# Response to reviewer's comments - Reviewer 1

# Modelling hazards impacting the flow regime in the Hranice Karst due to the proposed Skalička Dam

110 Figure 1: Locality of interest - present state (base map from [CUZK 2024](#))

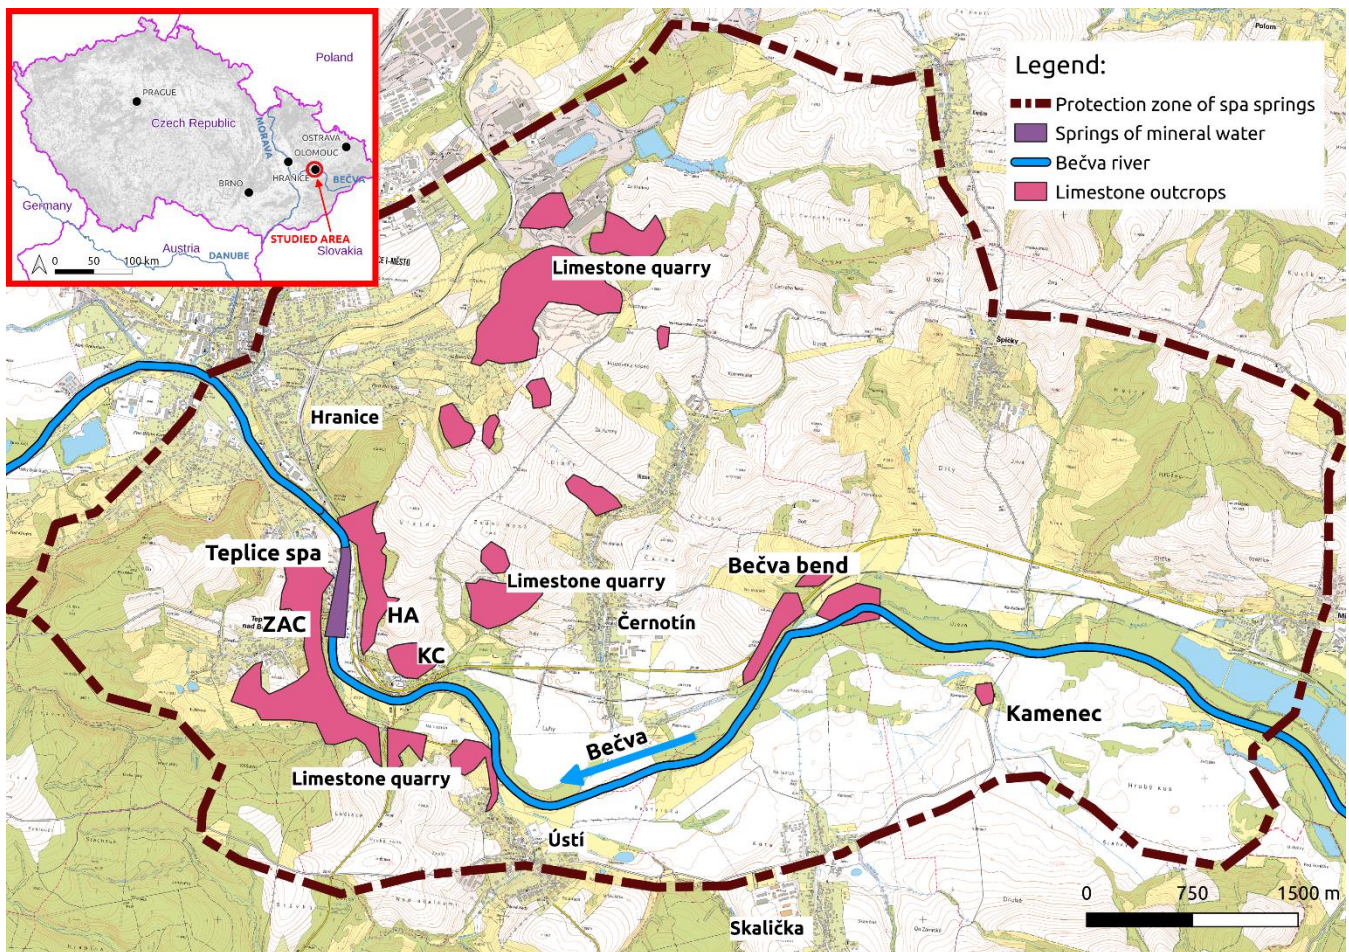
11. (L96) The figure is not really good. What is the position and extent of the karst region? Where is the dam project? Where are the caves, springs and Spa?

The Fig. 1 will be simplified, the Bečva river will be depicted together with the general location of the study area. The reference will be added to the Introduction.

155 **Figure 2: The detail of the Hranice Karst with the locations of the two variants (through-flow, lateral) of the dam (CUZK, 2024)**

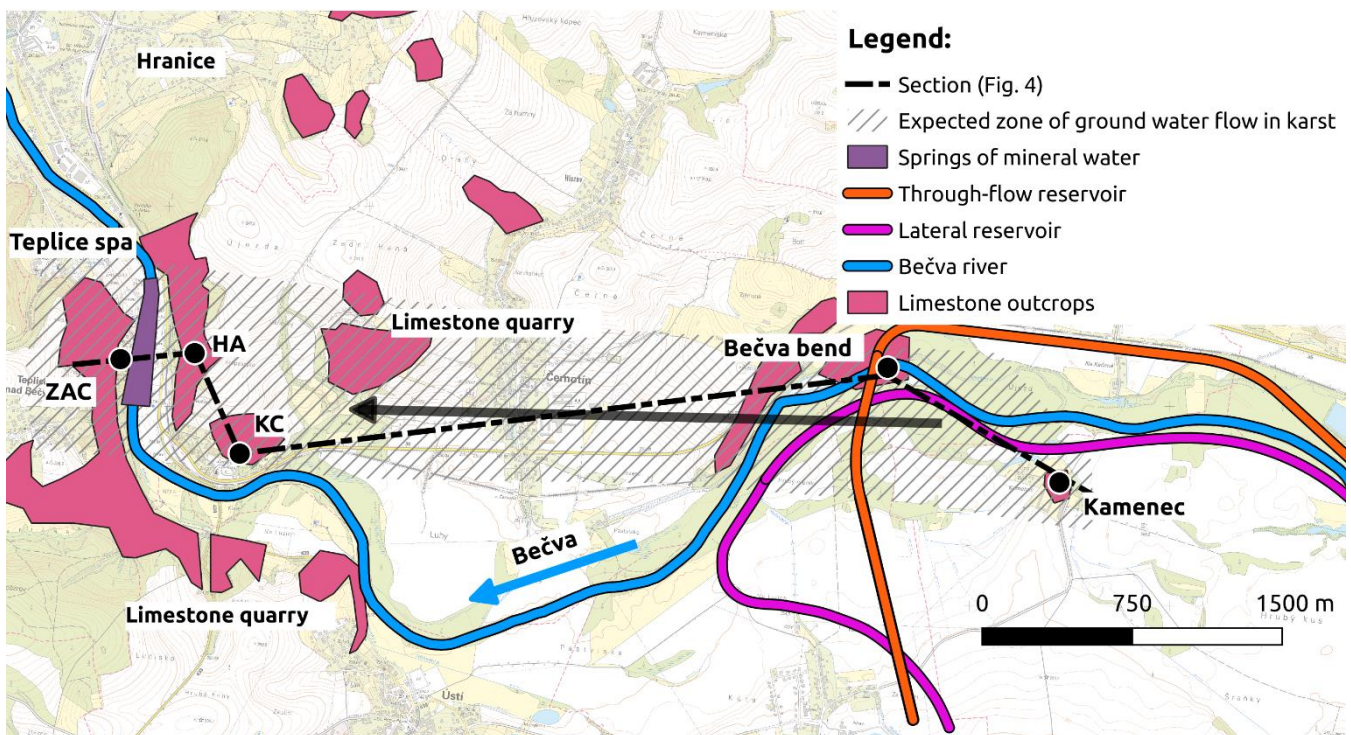
In fact Figure 2 provides most information but is not mentioned until line 104... I believe that figure 1 should be simplified and used as a small location map on figure 2.

The Fig. 2 will be improved, the protection zone of the Teplice spa, limestone outcrops and the dam location will be depicted.

**Figure 3: The detailed interpretation of ZAC and HA in the Teplice spa, cross section from ZAC to HA in Fig. 2 (Sracek et al., 2019), vertical and horizontal scales are the same.**

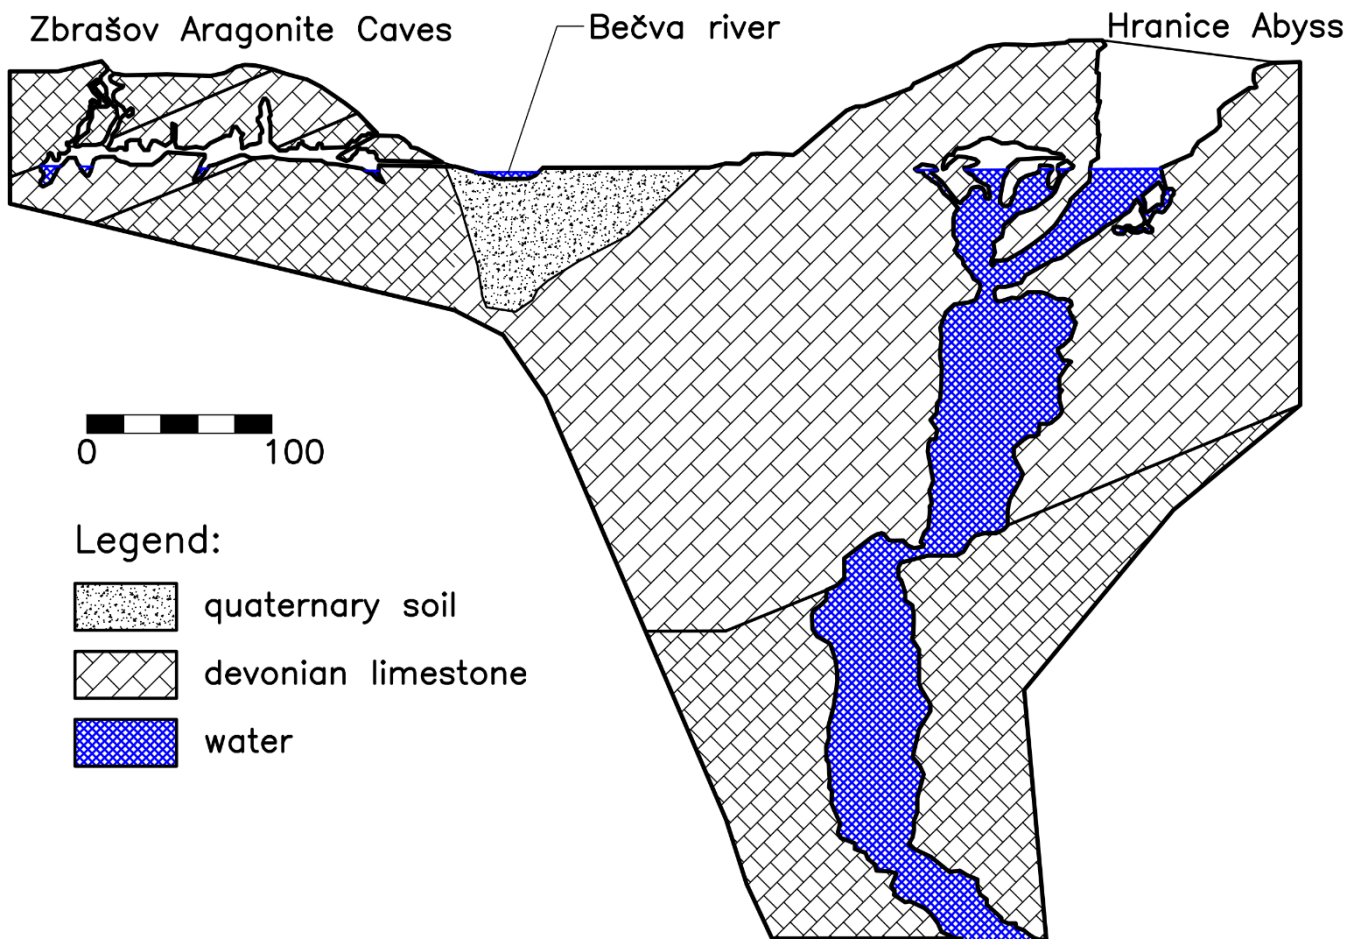
What is "Section" ZAC and HA? Where are the caves?

17. (L177) Is this a fault? Why are the rock layers hardly displaced?

The Fig. 3 will be improved and scaled.

It is not a fault, it is the line at which the cross-section changes its direction. Fig. 3 will be improved. Moreover, new more detailed sketch - schematic cross section will be added, as suggested by the reviewer (comment No. 29).

Figure 4: The sketch with conceptual model of a karst system

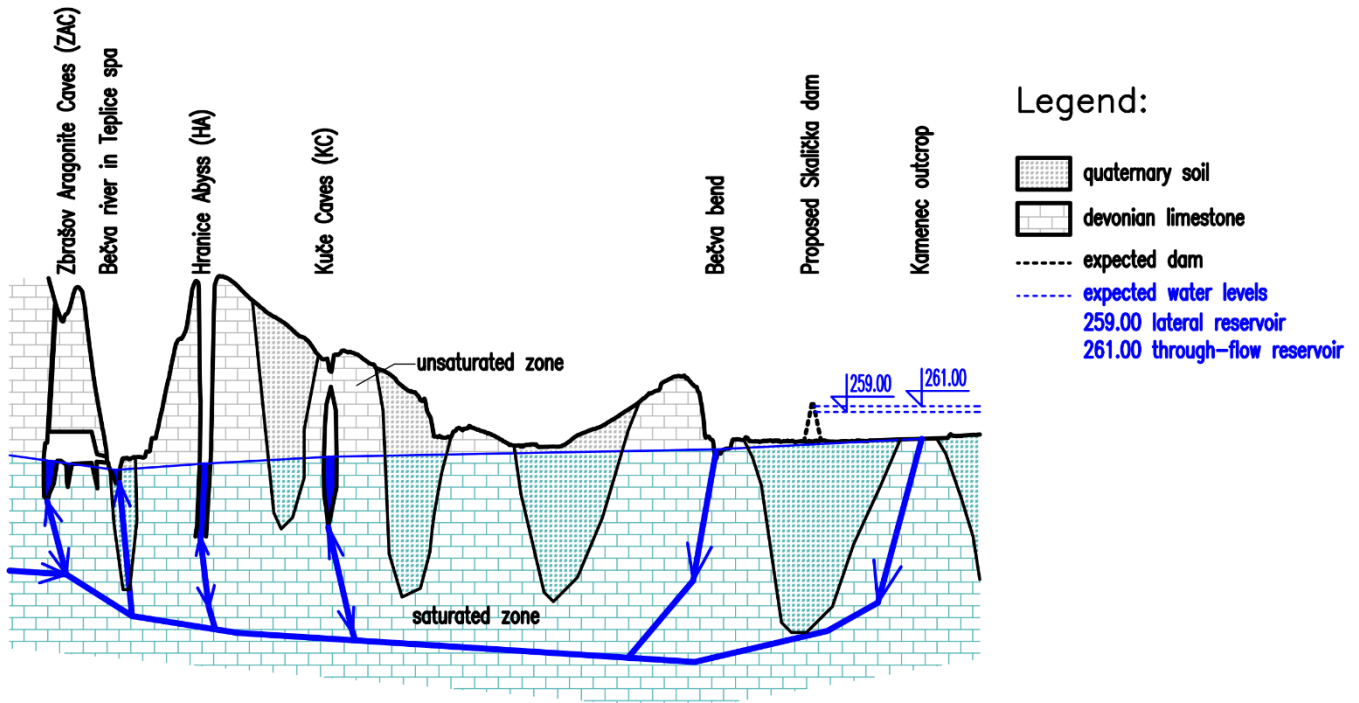
29. (L304) This part is difficult to understand. some sketches would be welcome.

The sketch (Fig. 4) will be added.

Figure 5: Diagram of the conceptual model: red arrows represent water inflows to the karst aquifer; black arrows represent flow directions in karst conduits.

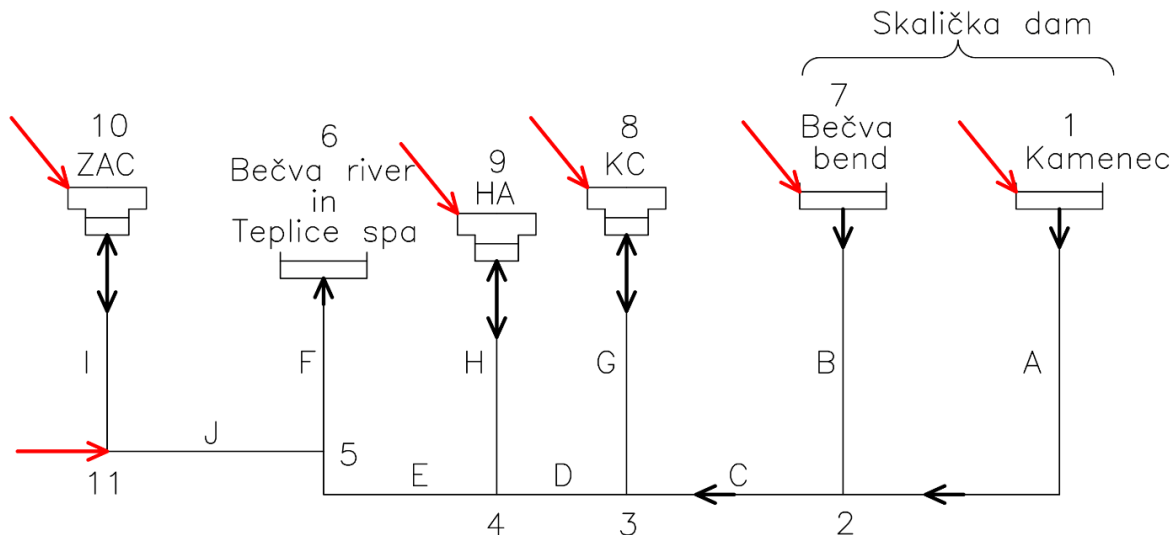
25. (L230) What do the numbers 1, 7 and 6 mean? The legend should explain it better.

26. (L232) The legend is incomplete. Please explain what is visible on your figure and what the reader is supposed to understand from this figure. **This comment is valid for most figures.**

The figures were improved, new sketch (Fig. 4) was included. The numbering was introduced in Fig. 5 based on the newly added sketch (Fig. 4). The first paragraph of the section 3.2 will be modified:

The Fig. 5 (newly Fig. 2) will be improved, the schematic sketch will be attached (Fig. 4).

The caption will be improved:

Figure 5: Diagram of the conceptual model: red arrows represent water inflows to the karst aquifer; black arrows represent flow directions in karst conduits. Numbers express the computational nodes of the system, capitals denote hypothetical karst channels
